Modification of Infrastructure Approval

Sydney	16 November 2023	
SCHEDULE 1		
Infrastructure Approval:	SSI-12590060 granted by the Minister for Planning and Public Spaces on 16 December 2022	
For the following:	Hunter Power Project (Kurri Kurri Power Station)	
Modification:	Modification 2 - Temporary Worker Accommodation Facility

(SSI-12590060-Mod-2)

Figure 3: Temporary Additional Area for the Temporary Workforce Accommodation Facility"

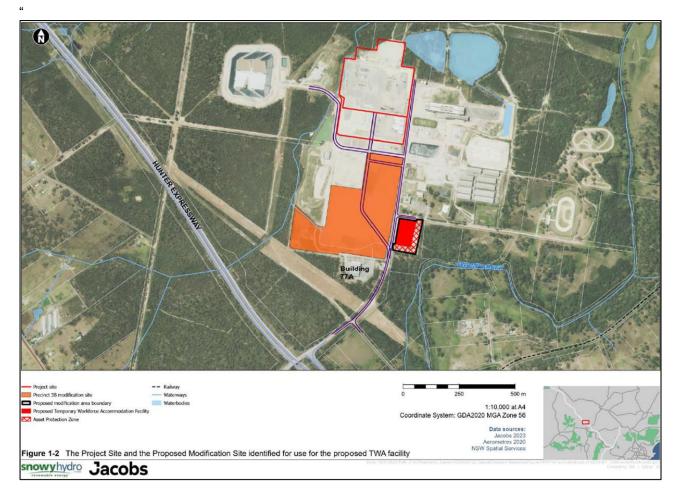
- A29. The Proponent may utilise the temporary additional area identified as Temporary Workforce Accommodation Facility in Figure 3 of Appendix 2 of this approval during construction only."
- 4. In Schedule 2, after condition B18, insert the following conditions:

9. In Appendix 2, after "Figure 2: Precinct 3B - Temporary Additional Construction Area", insert the following:
